Application No.	Applicant(s)
Notice of Allowability	10/718,476	STEWART ET AL.
	Examiner	Art Unit
	Charles D. Garber	2856
The MAILING DATE of this communication appears on the cover sheet with the correspondence address All claims being allowable, PROSECUTION ON THE MERITS IS (OR REMAINS) CLOSED in this application. If not included herewith (or previously mailed), a Notice of Allowance (PTOL-85) or other appropriate communication will be mailed in due course. THIS NOTICE OF ALLOWABILITY IS NOT A GRANT OF PATENT RIGHTS. This application is subject to withdrawal from issue at the initiative of the Office or upon petition by the applicant. See 37 CFR 1.313 and MPEP 1308.

## **DETAILED ACTION**

## Allowable Subject Matter

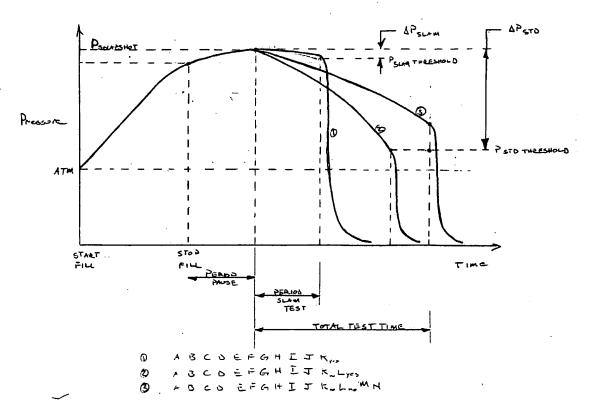
Broadest claim 1 may be more easily understood by referring to the following illustration substantially depicting the test pressure trace and the three possible outcomes. The test part, sealing with a fill line and pressure sensing means (step B) as well as presetting of parameters (step A) shown below are not separately illustrated as these structures and steps are well known and understood in the art.

The traces 1, 2 3 are explained in the legend in terms of the claim steps A through N. In brief, a test part is filled (until presumably a target fill pressure or fill

time is achieved), sealed, allowed to stabilize (pause period), snapshot (e.g. tare) pressure (shown as  $P_{SNAPSHOT}$ ) is then recorded and the pressure permitted to begin decaying.

The test continues until a "slam" test period expires where if the current pressure is above snapshot pressure minus slam differential value (P >  $P_{SNAPSHOT}$  -  $\Delta P_{SLAM}$  is True) the part has little or no leak and is indicated good. This is essentially a quick test and the part is vented if good and the test is terminated.

Otherwise, the test continues, repeatedly measuring and evaluating the current pressure until either it falls below a threshold defined by  $P_{SNAPSHOT}$  -  $\Delta P_{STD}$  at which time the part is indicated bad and vented or until total test time expires at which time the part is indicated good and vented.

For the purpose of more effective and helpful disclosure, if Applicant wishes to amend drawings and specification to include an illustration similar to the one above, Examiner would consider this to be no new matter.
